**ADDENDUM NO. 2**  
**Woodruff Landfill: Phase 7 Expansion Construction (Rebid)**  
**Transylvania County, North Carolina**

SUBJECT: ADDENDUM NO. 2 dated March 27, 2025, to the Contract Documents for the Woodruff Landfill – Phase 7 Expansion Construction (Rebid), dated February 21, 2025.

BORROW AREAS  
EROSION AND SEDIMENT  
CONTROL PLAN  
PHASE 1

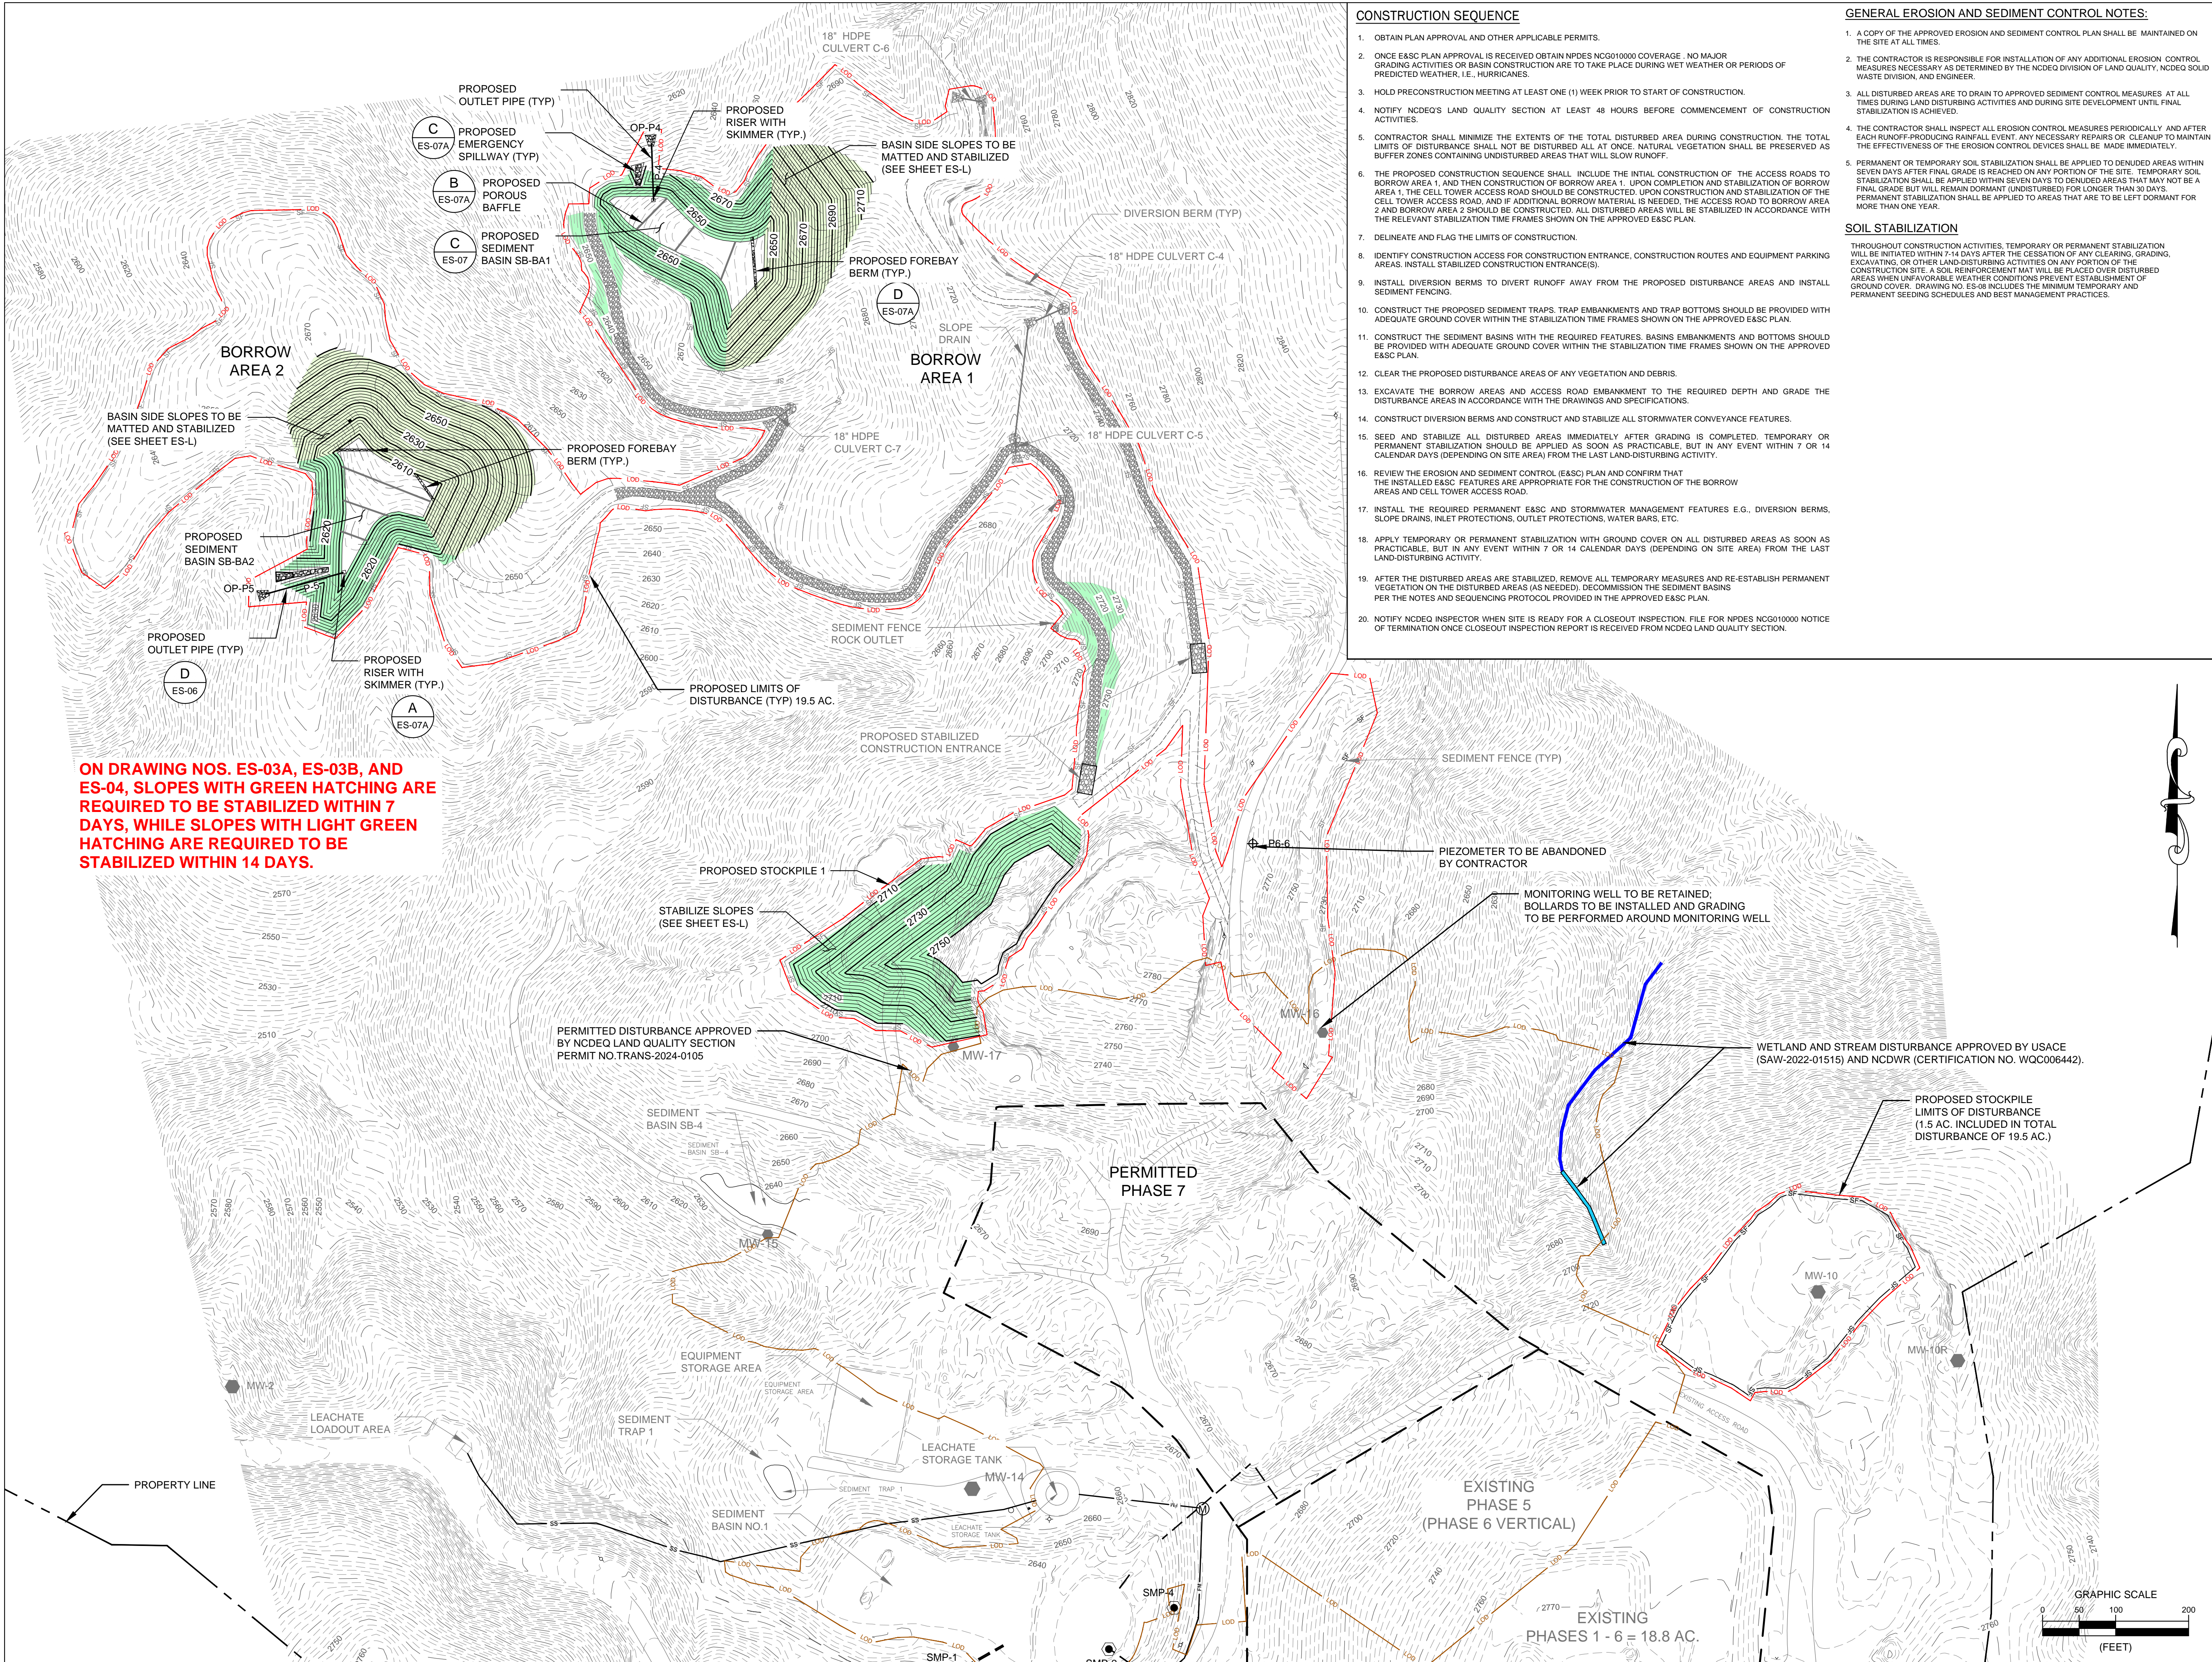
- inlets for this pipe run, i.e., one for each of the two (2) culvert pipes.
- Q.5 Please confirm the lengths for Sediment Trap ST BA 1 and ST BA 2 on Sheet CP-03B.

- A.5 Please refer to the attached Drawing No. ES-03A that shows the dimensions for the two temporary sediment traps (TST-BA1 and TST-BA2). Additionally, refer to C.1 in this addendum for further details about the conversion of the temporary sediment traps to sediment basins to be performed by the CONTRACTOR.

**ES-03B**

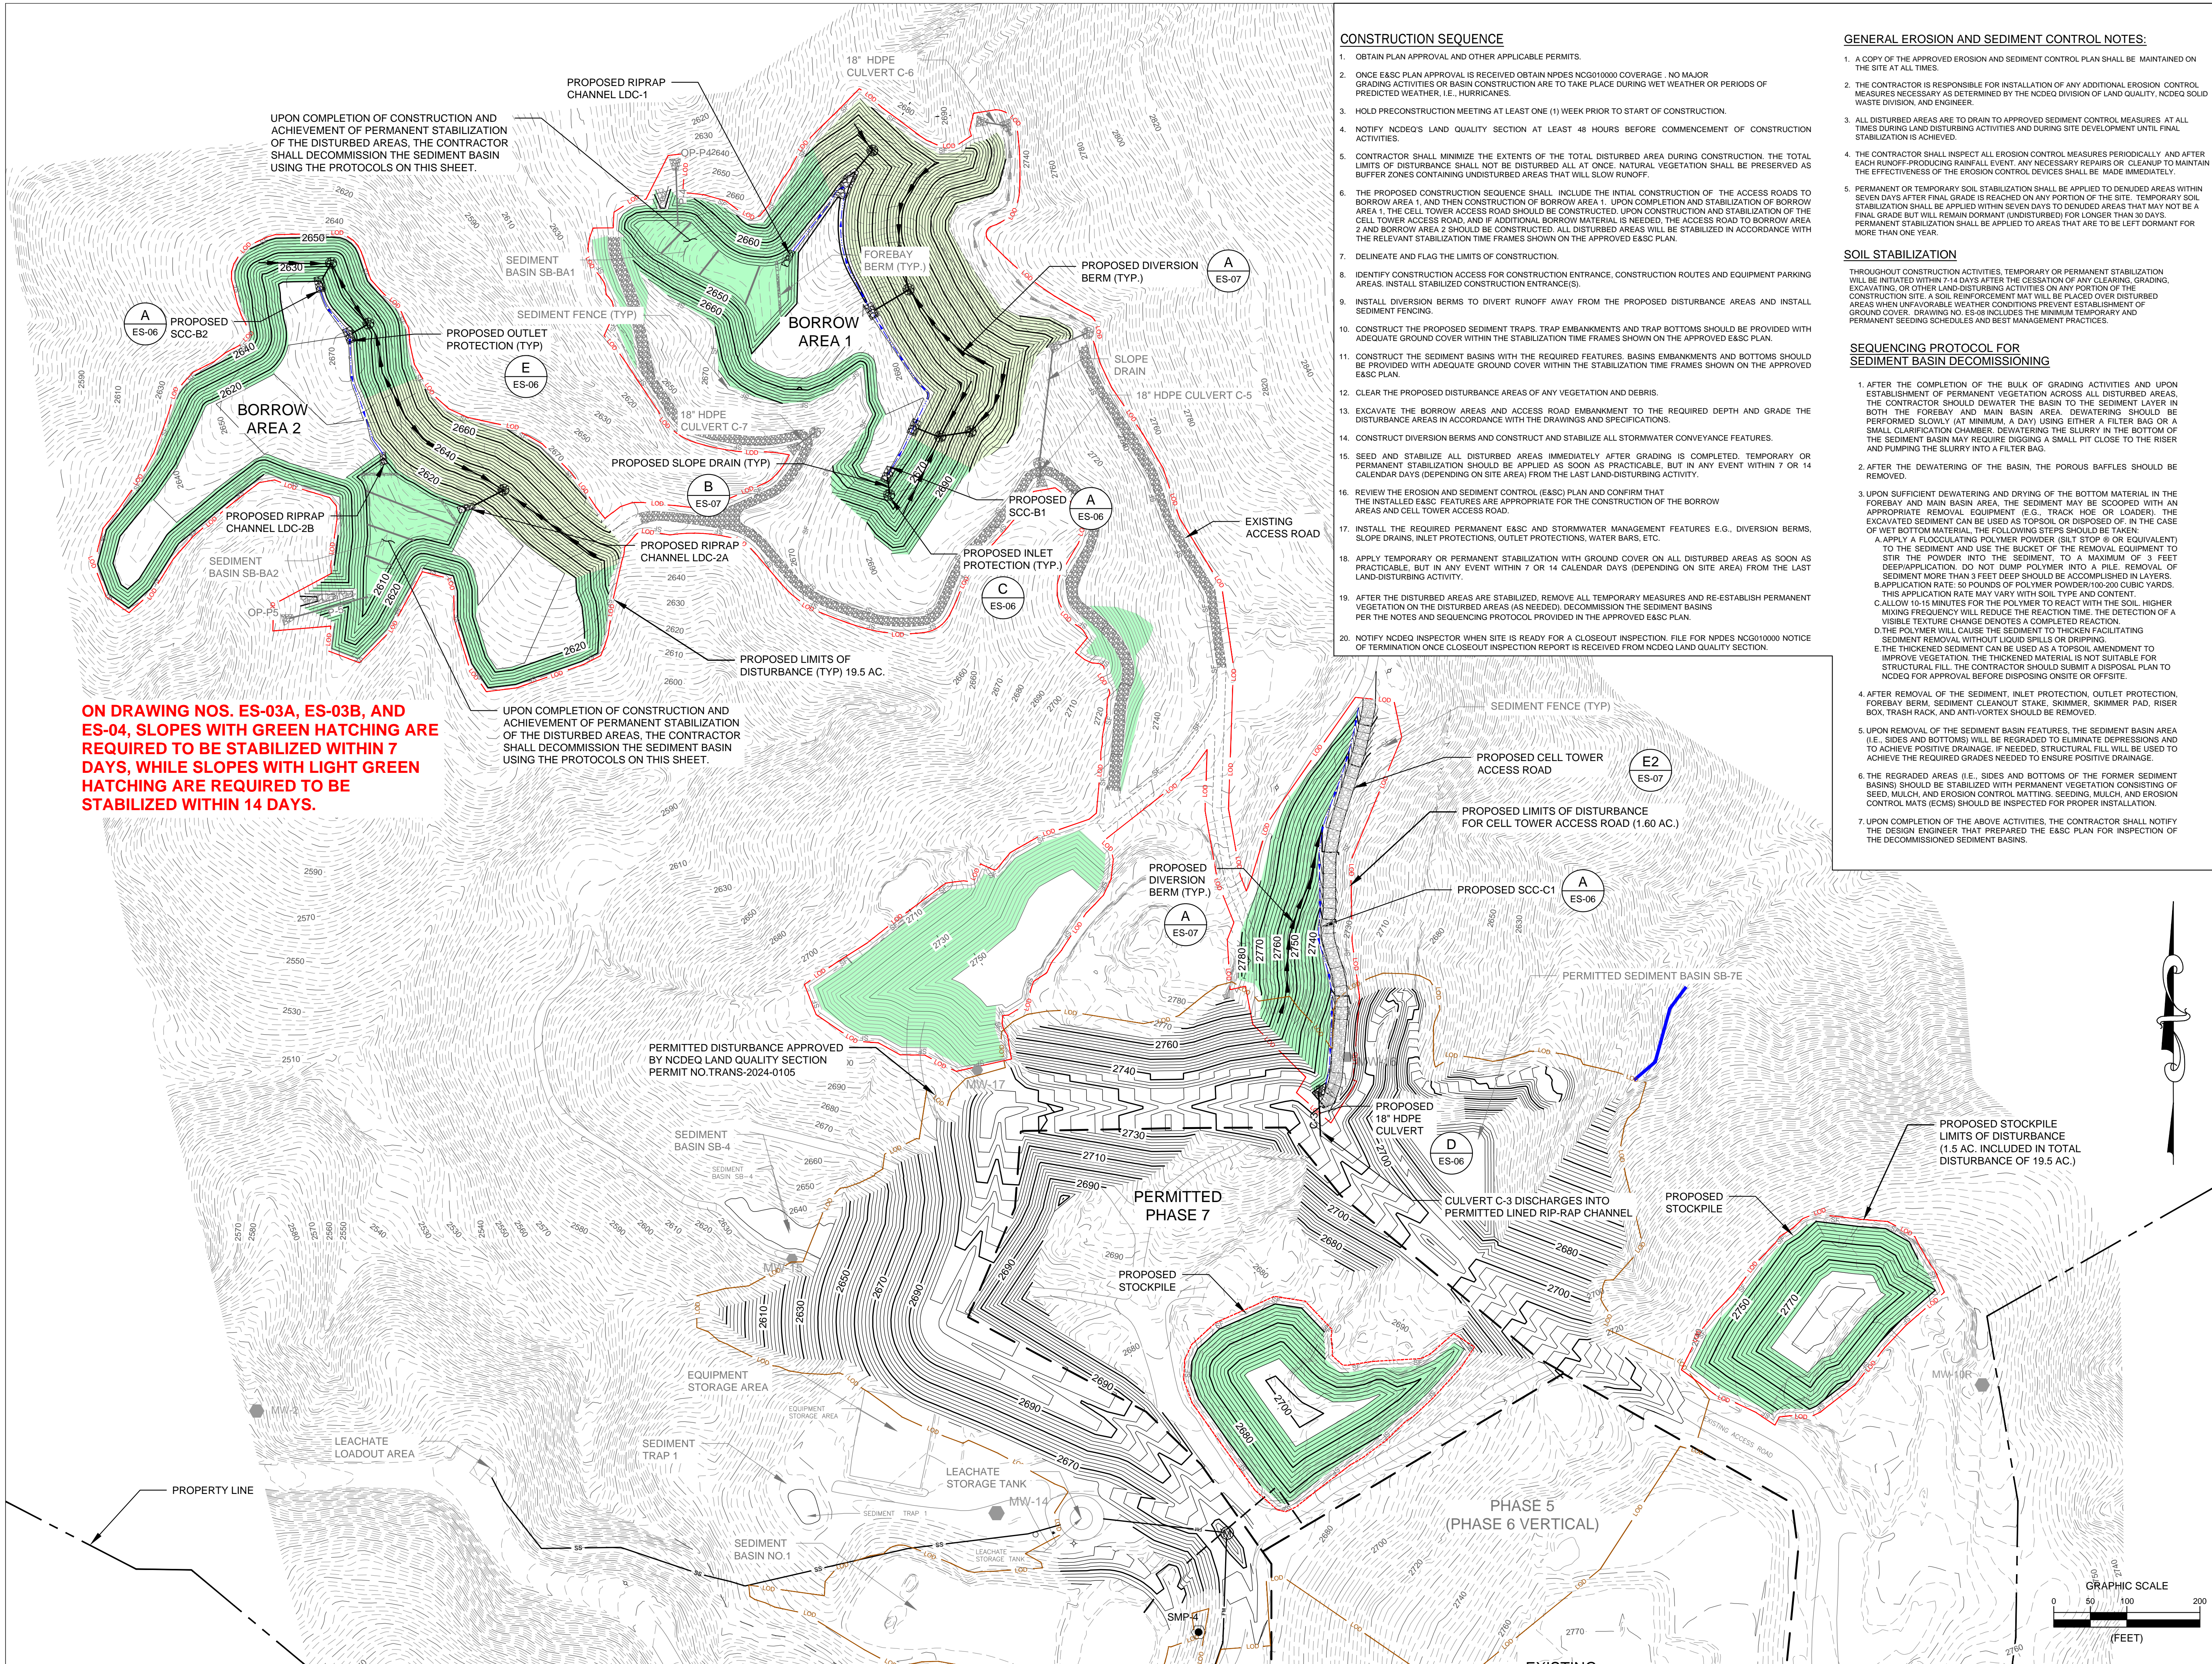
C.1 Based on NCDEQ review comments on the Erosion and Sediment Control (E&SC) Plan submitted for the proposed Borrow Areas, the two (2) temporary sediment traps (TST-BA1 and TST-BA2) will be constructed during the initial phases of land disturbance. Subsequently, the sediment traps will be expanded and converted to sediment basins (with forebays, risers with skimmers, baffles, and outlet pipes) by the CONTRACTOR. The details of the conversions from the sediment traps to sediments, and the decommissioning of the sediment basins after the establishment of permanent stabilization, are shown on newly issued Drawing Nos. ES-03B, ES-04, ES-07, and ES-07A.
